Access Compliance Report Public Rights-of-Way (Curb Ramps)

Main Street: EMBARCADERO_PL		Cross Street: DANA_POINT_HARBOR_DR		Location:	SE
ADA ID: RPRK220208154928	Ramp Type:Type 1 - Perpendicular	Initial Pass/Fail: Fail	Overall Compliance: No	Severity Score:	2
Codes/Mitigation Info/Possible Solution			Field Measurements/Component Compliance

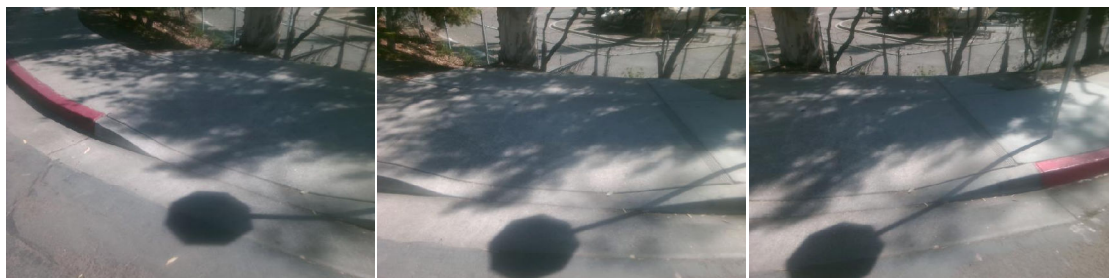
R204.3, R304.5.3, STD 1115

Remove & Replace Entire Ramp.
